Technical Bulletin

Number: 034
Date Issued: 11/12/03
Expiration Date: 11/12/04

Subject/Key Words:	GAMA Plenum Door Latches & Handles		
Classification:	<input checked="" type="checkbox"/> Informational	<input type="checkbox"/> Mandatory	<input type="checkbox"/> Safety Alert
	<input type="checkbox"/> Warranty Impact	<input checked="" type="checkbox"/> Purchase Parts	<input type="checkbox"/> PM Impact
Applicable Akrion Procedures:	N/A		
Parts/Reference Documents:	221898-001		
Attachments:	N/A		
	<input type="checkbox"/> No Charge For Parts expires ___/___/___. Reference this TB# when ordering NC parts.

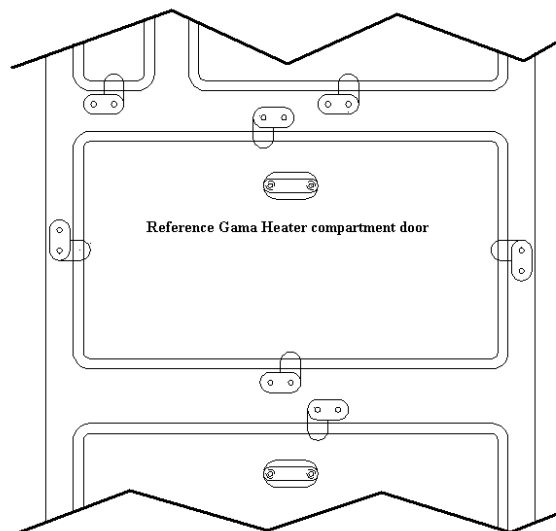
Issue: Plenum door latches and handles may wear/break over time.

Symptoms: Worn or broken door latches may cause the following:

- Poor sealing of the plenum doors.
- Pneumatic Interlocks to not engage completely.

Solution: As part of the Akrion Continuous Improvement Program (CIP), the latches and handles have been redesigned and are available as a purchasable kit. The kit can be ordered via Akrion part # 221898-001 through Akrion's Parts Logistics department. One kit is needed per module and fits every type of plenum. Below is an example layout of the new latches and handles.
